Special Bulletin

SP15-343D

SLIDING DOOR ADJUSTMENT AND HARDWARE REPLACEMENT

Prevost vehicles

Figure 18

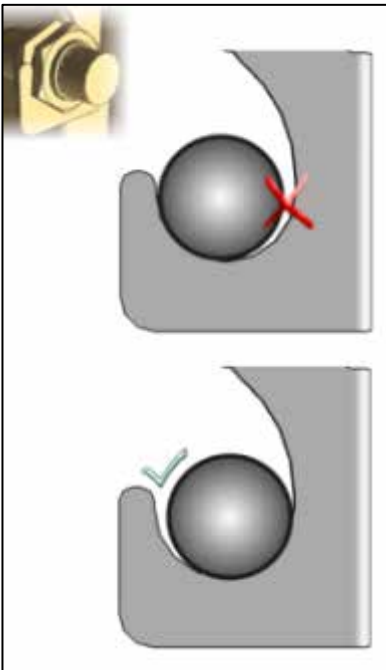
16. On the proximity sensor, remove the 24mm nut. Clean threads to remove any traces of Loctite. Install two washers, one on each side of the support bracket.

17. Place proximity switch in support opening as shown below, pushing it down and curbside in the opening.

18. Apply Blue Loctite 243 #680038.
19. Adjust to $3/4 \pm 1/16$ " (19 ± 2 mm) (Figure 19)
20. Firmly tighten with wrench.

Figure 21

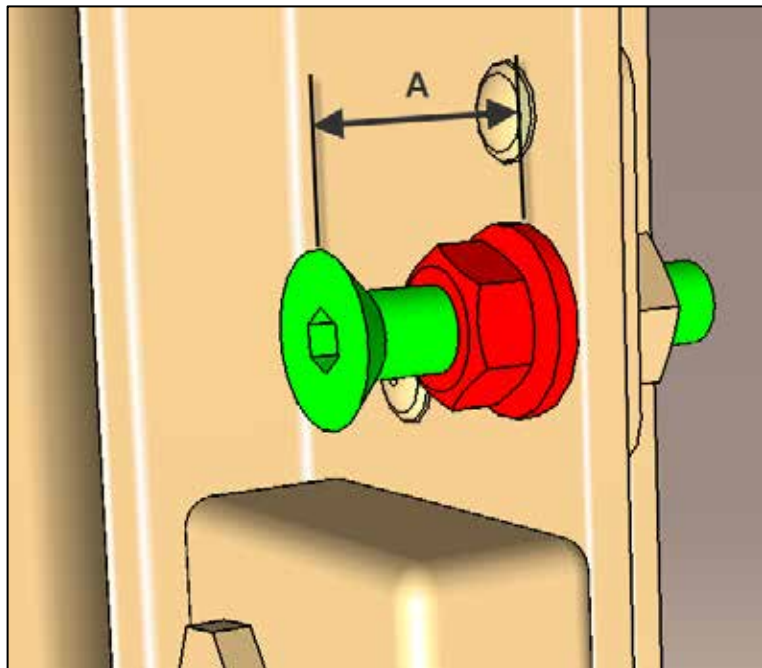
22. Replace screw by flat socket head cap screw and replace washer.
Screw #500117 (1x).
Bel Washer: #5001868 (1x)
Hand tighten and adjust to $13/16'' \pm 1/16''$ (21 \pm 2mm) **(A)**
(Figure 21)

Figure 22

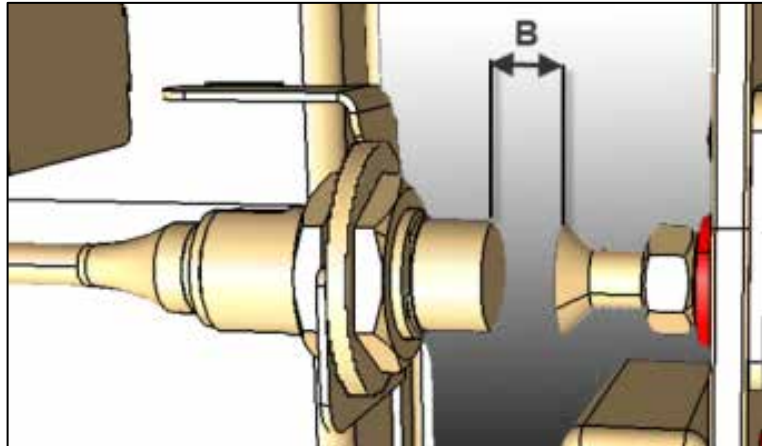
23. Adjust gap between proximity switch and cap screw to $5/16'' \pm 1/32''$ (8mm \pm 1mm) **(B)** (Figure 22)
24. Door side, hold cap screw and tighten nut to **16 lb-ft** using a crowfoot adapter for the torque wrench.
25. Apply torque seal mark.

Figure 25: top view

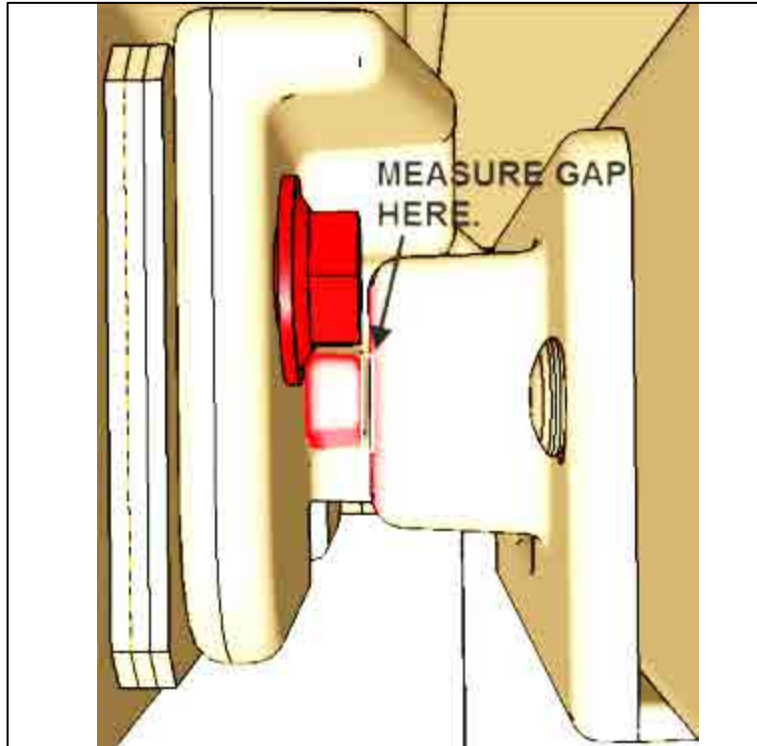
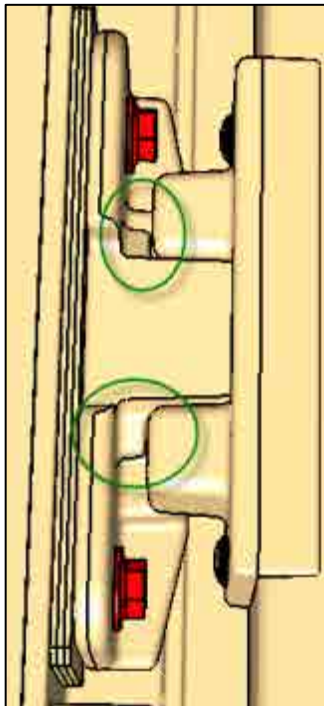
Looking at the fingers from the top. Use feeler gages to assess the gap between the small boss on the finger and the receptacle face

Use a feeler gage to confirm gap

Min **1/64"** (0.5mm)

Max **3/64"** (1.1mm)

If gap is not within the above values, add or remove shims as required.

#288588 18GA

#2800296 24GA

Figure 31

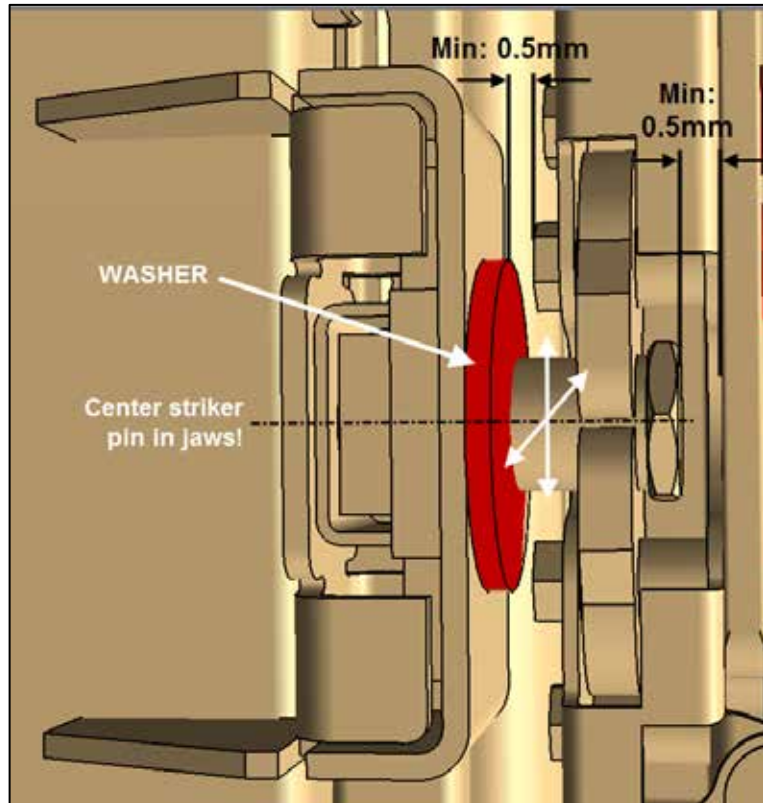
35. Tighten to **60 lb-ft**
36. Apply torque seal.
37. Control gaps as shown on Figure 31. Min **1/64"** (0.5mm)

No washers should be installed on the striker plate housing screw heads

If gaps are smaller, inform your Prevost Regional Service Manager (RSM).

Figure 35

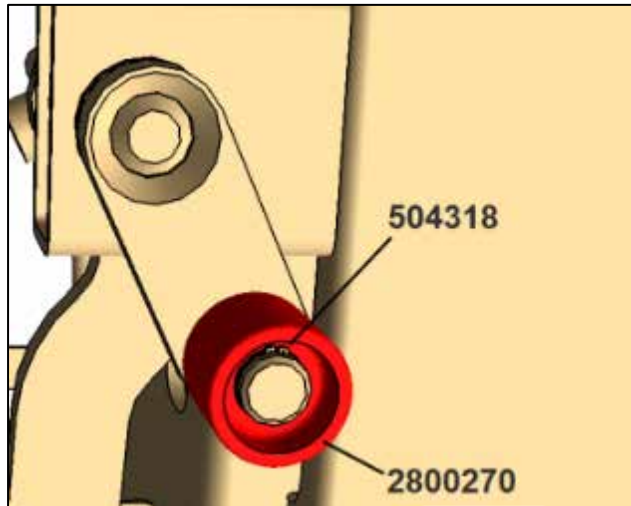
40. Inspect roller condition.

Rollers should be free of flats, and have a smooth surface finish.

Replace the roller as required.

#504318 Retainer Ring

#2800270 Roller

Figure 36 Upper plate

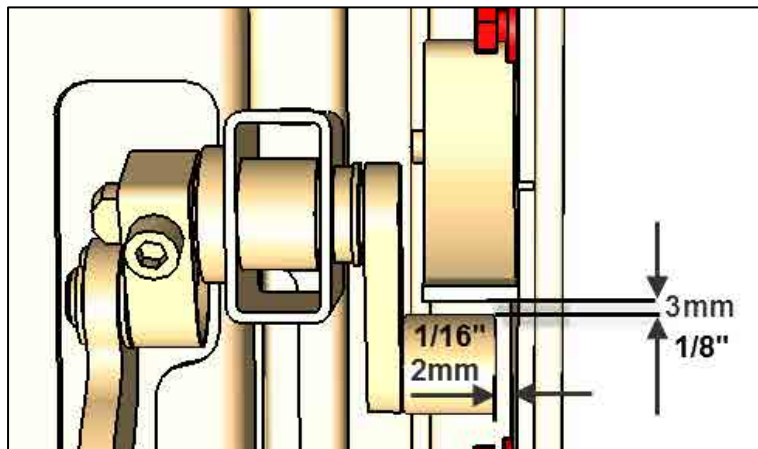
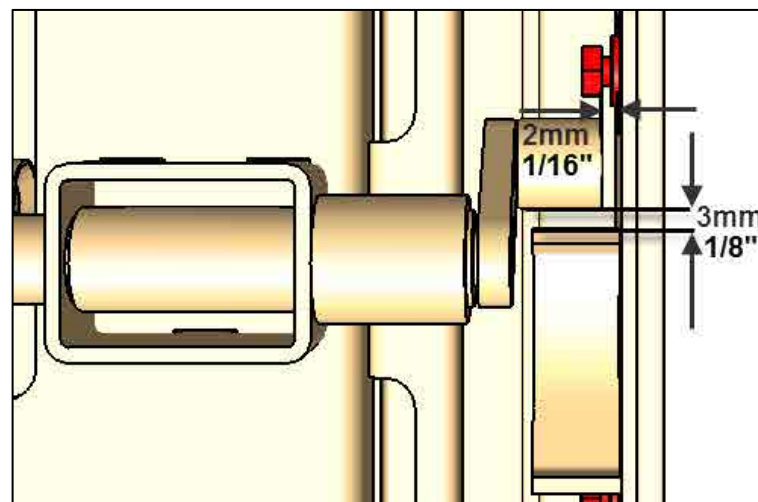
41. Distance between *roller and plate* with door closed should be **1/8"** (3mm).

Adjust as required on upper and lower catch plate.

42. Gap between *roller end and door* should be minimum **1/16"** (2mm).

Trim roller end as required to get closer the target value.

Figure 40

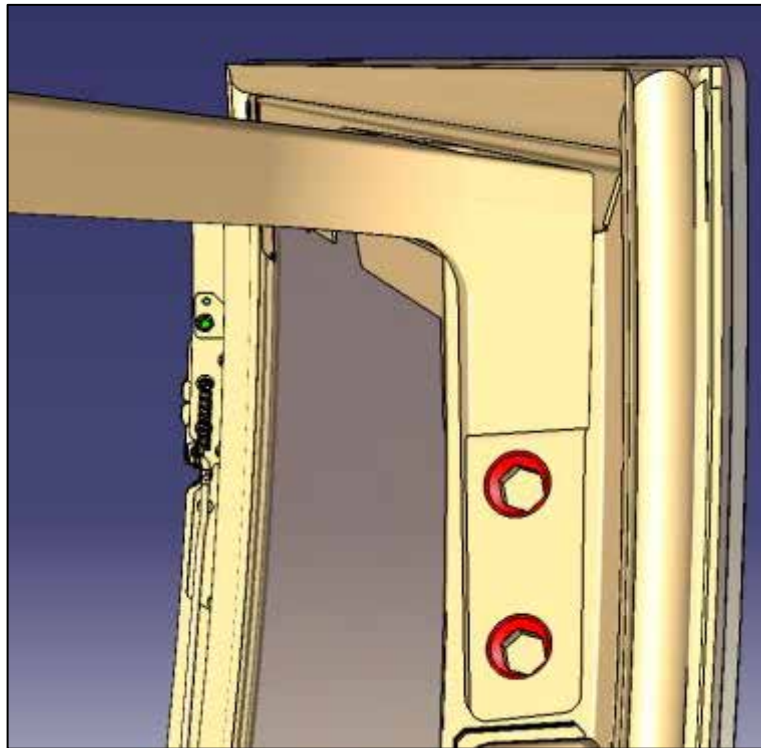
- 49. Open the door.
- 50. On the door upper arm, vertical face, remove one screw at a time and replace washer.

Bel. Washer #5001848 (2x).

- 51. Tighten to **16lb-ft**
- 52. Apply torque seal mark

Figure 41

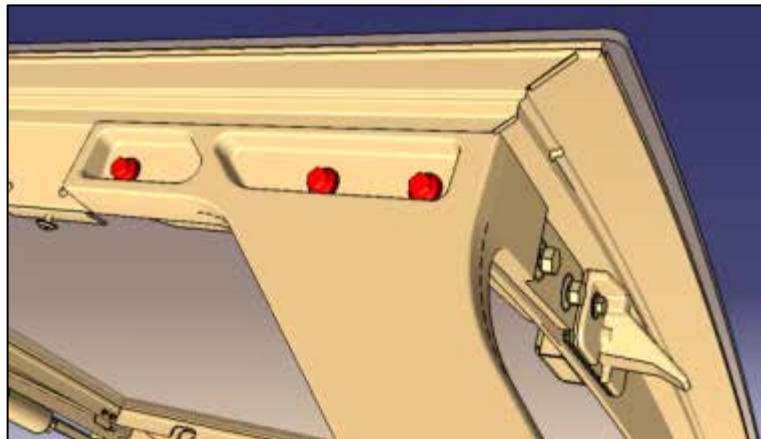
- 53. On the door upper arm top, remove mounting screws one at a time and replace washers

Bel. washer #5001833 (3x)

- 54. Tighten to **7 lb-ft**
- 55. Apply torque seal mark

Figure 46

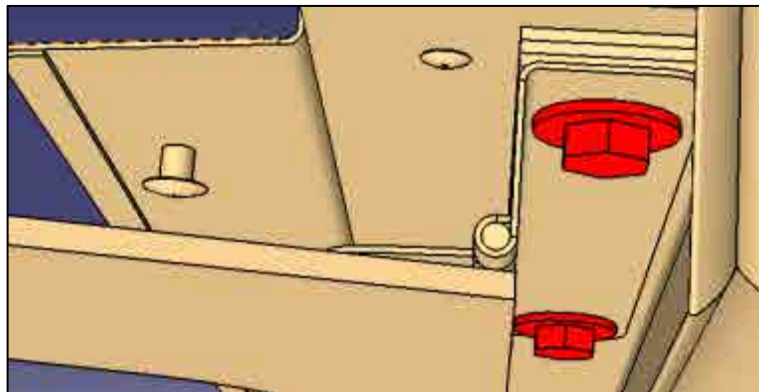
- 68. On the door lower arm, remove screws one at a time and replace the washers
Bel. washer #5001833 (2x)
(Figure 46)

- 69. Tighten to **7 lb-ft**
- 70. Apply torque seal mark.

Figure 49

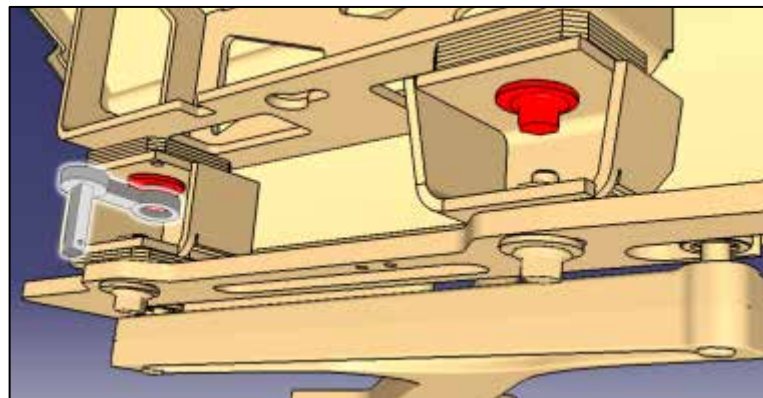
72. *Keep the original flat washers, remove one screw at a time and replace with:*

Screw #N16891 (2x)

Bel. washer #5001834 (2x).
(Figure 49)

73. Tighten to **34 lb-ft**

(Specific torque+2lb-ft)

Figure 50

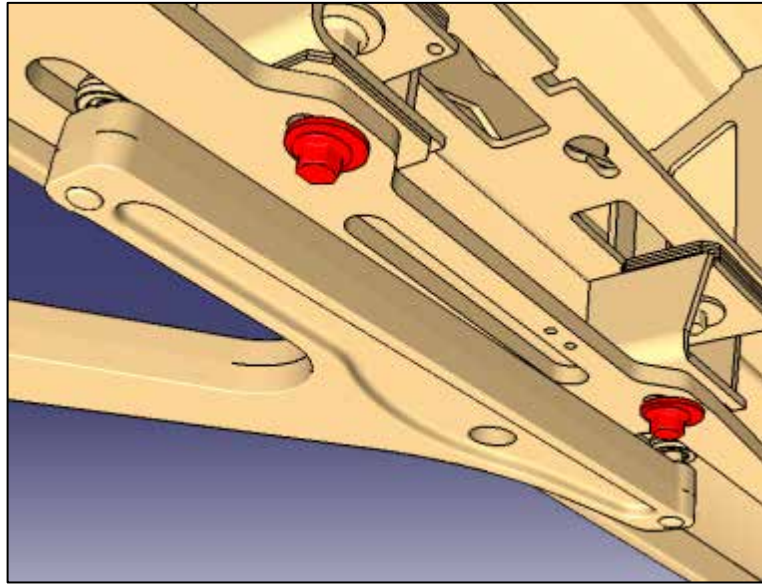
75. Have the door fully open.
76. *Keep original flat washer* remove one screw at a time, replace screw and washer with:
- Screw #N5001308 (2x).
Bel washer #5001834 (2x),
(Figure 50)

Figure 51

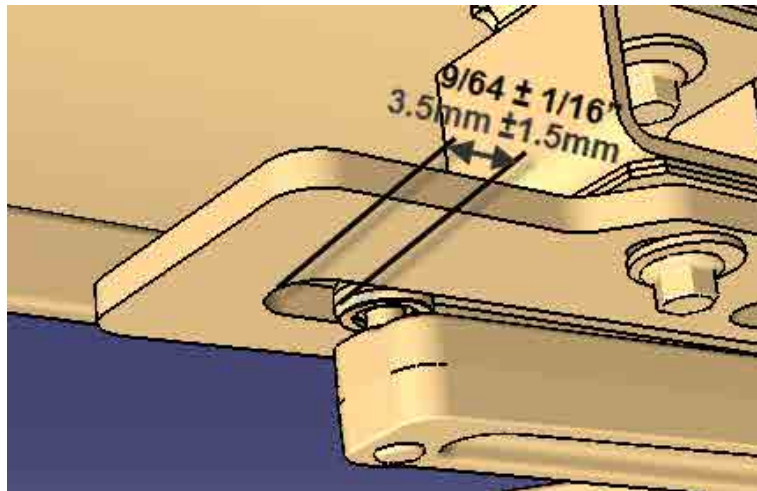
79. Distance between the end of both fork slots and roller should be:

9/64 ± 1/16"

3.5 ± 1.5mm

Figure 53

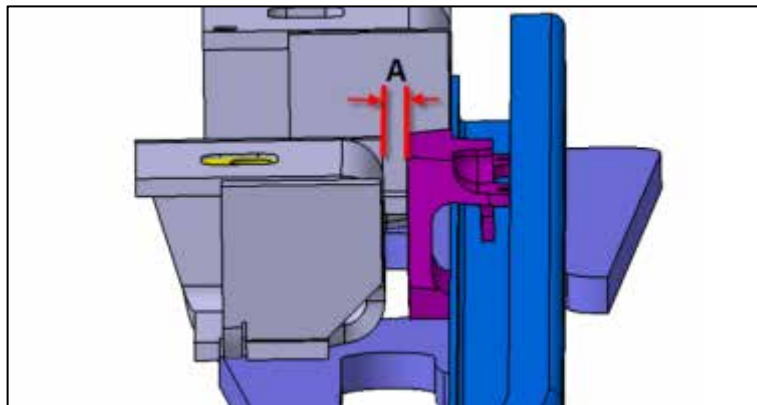
81. Minimum gap between the aft fork support and wheel carrier should be $1/32$ " (1mm) (dimension A)
Confirm with feeler gage. (Figure 53)

Figure 55

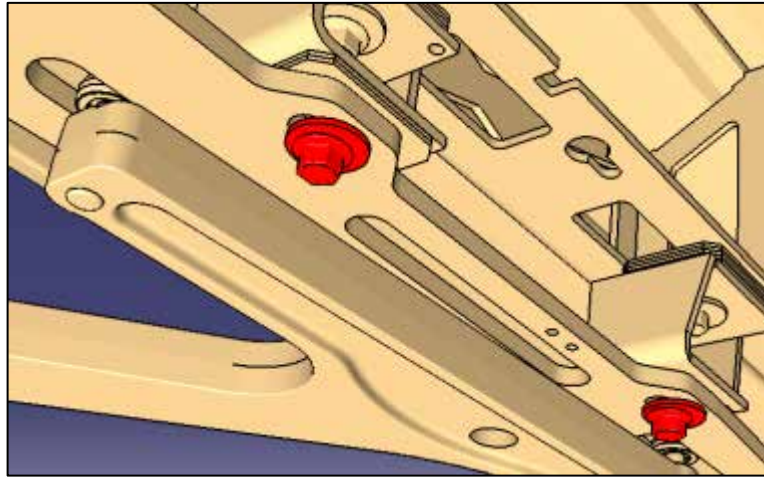
83. Once everything is inspected and centered, Tighten fork screws to **32 lb-ft.** (Figure 55)
84. Add torque seal mark.

Figure 59

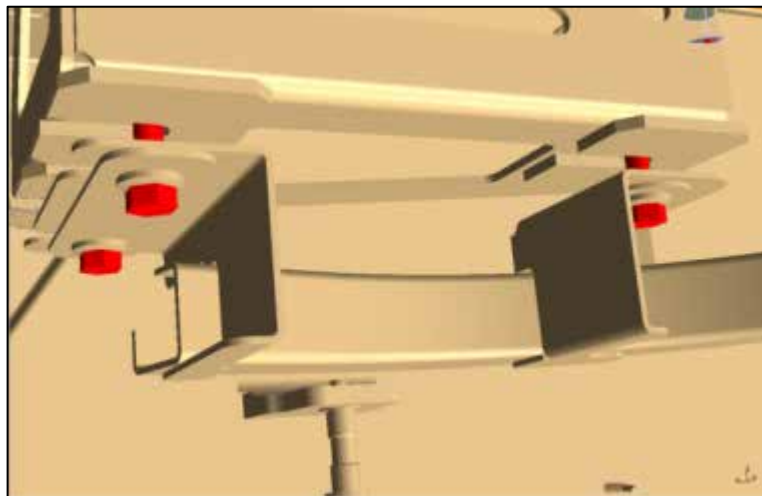
89. Inspect all three wheels on the carrier they should turn freely. If not change the carrier assembly. Part number 2800282.
90. With closed door, unscrew the bolts for the rail supports and remove all shims.
91. *Keep original flat washer* remove one screw at a time and replace washer with:
Bel. washer 5001848 (2x aft) (1x fore).
(Figure 59)

Figure 61

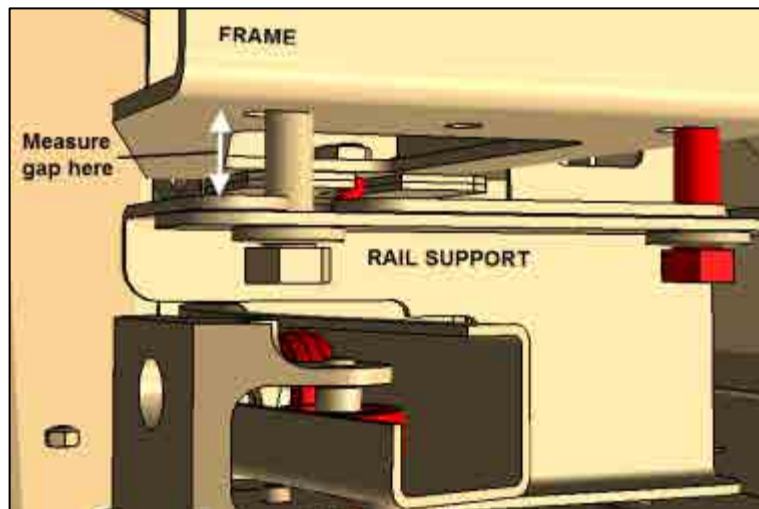
93. Measure the gap between the rail support and frame. (Figure 61)

Calculate the required number of #286421 shims equivalent to the gap value minus 5/32". See calculation example below.

Figure 64

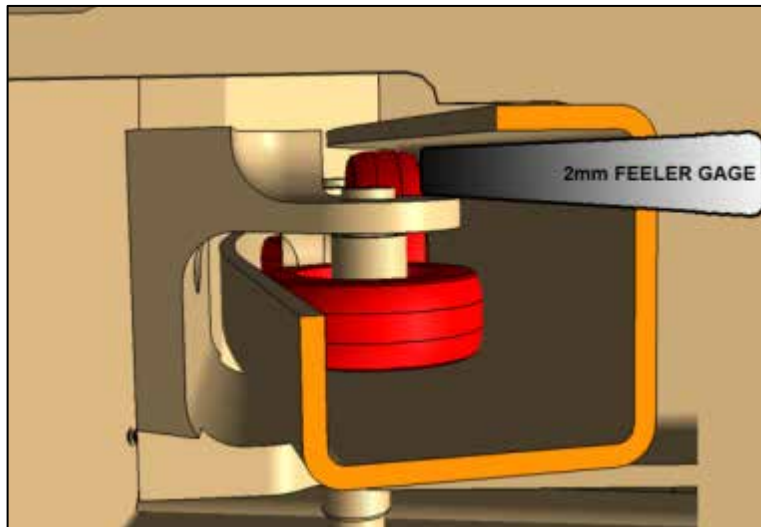
96. Next, apply the proper gap for the horizontal wheels. Insert a **5/64"** (2mm) feeler gage behind the vertical wheel. (Figure 64)

97. Pull on the rail support towards the inside of the bus to have the proper gap.

Figure 65

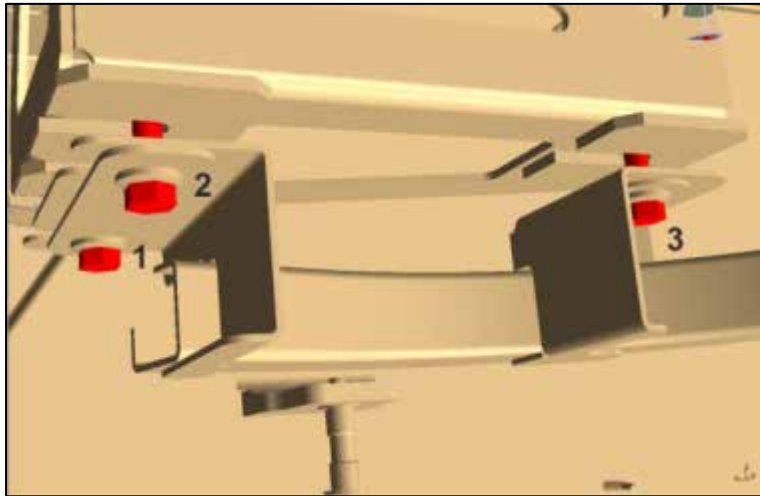
- 98. Tighten all three screws to **16 lb-ft.** (Figure 65)
- 99. Start with the rear screws and end with the front screw.
- 100. Apply torque seal mark.

Figure 67

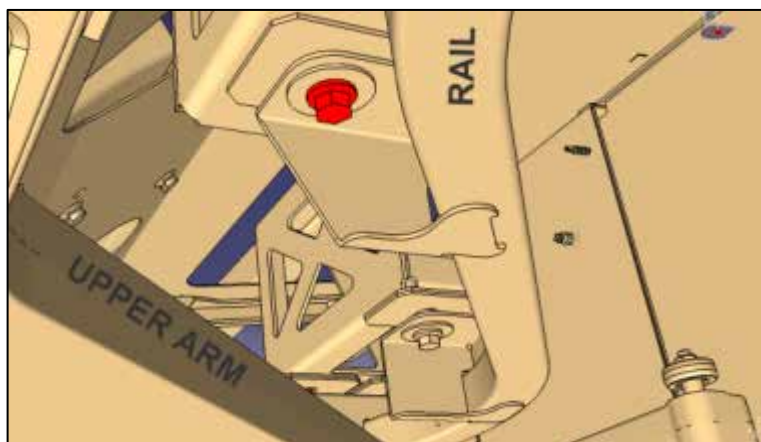
- 102. Keep the original flat washer but replace the Belleville washer by
Bel. Washer # 5001848
(1x)
(Figure 67)

- 103. Tighten to **16 lb-ft**
- 104. Apply torque seal mark.
